JLG 17245 Dickinson Town Square

RE: PR 004 - Ice Infrastructure Power

## Proposal Request 004

**ENGINEER'S PROPOSAL REQUEST**

**ICE CHILLER ENLARGED PLAN**  
 SCALE: 1/4" = 1'-0"

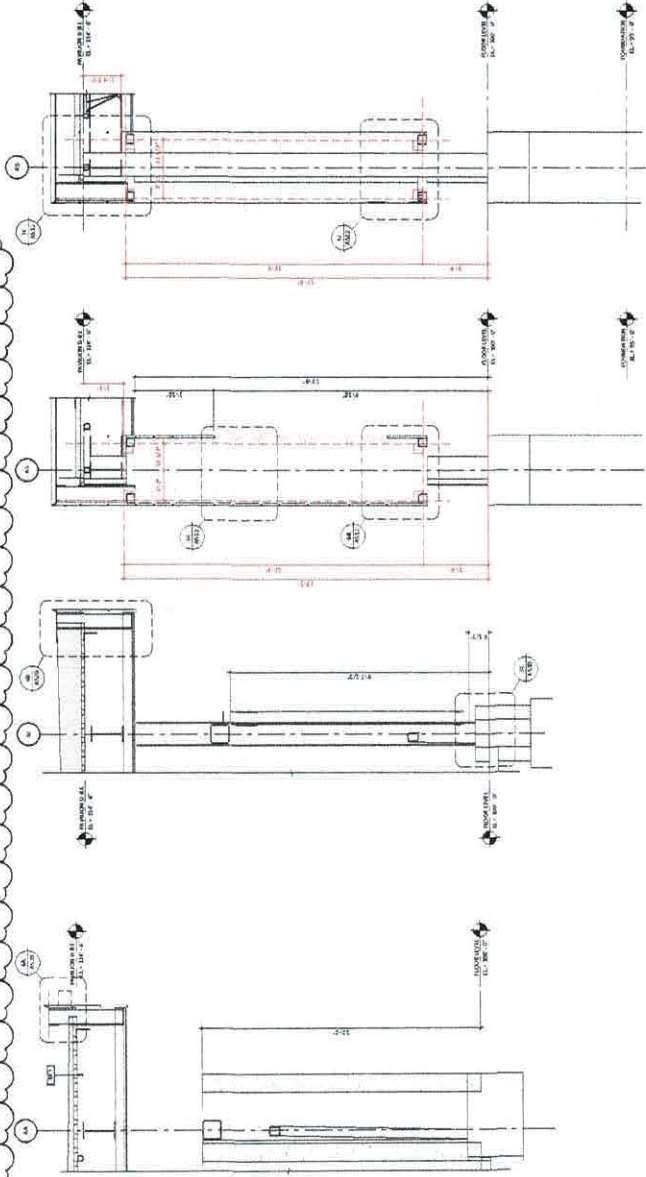
1. Power infrastructure for supporting Owner provided Ice Rink Chillers.
2. See attached Engineers Proposal Request: EPR #E-4, for electrical description of work.
3. See revised Sheet A502, new details 3C and 6C, for location details of power infrastructure.

1. Sheet E101, Electrical Site Plan
  - a. Detail 1/E101: Provide power connections in planting bed north of Pergola 2 as follows for portable ice chillers:

- i. Provide two WP 100/3 fused disconnect switches. Provide (4) #2 AWG conductors (3 hot, 1 neutral) and one #8 AWG equipment grounding conductor from each disconnect to spare breakers in MDP (2 thus). Each chiller disconnect to be served from separate breaker.

- ii. Provide neutral bar in each disconnect to terminate neutral conductor. Neutral conductor to be for future use.
    - iii. Disconnects to be mounted such that they are a minimum 24" AFG, and provide 3' of clearance in front of disconnects from front face of planter. Provide two treated 4x4 posts for each disconnect for mounting. Provide galvanized or painted uni-strut across posts for mounting of disconnects.

- iv. Verify fuse sizes required for chiller equipment and provide fuses per manufacturer recommendations.
2. See attached Sheet A502 for detailed installation requirements and locations.
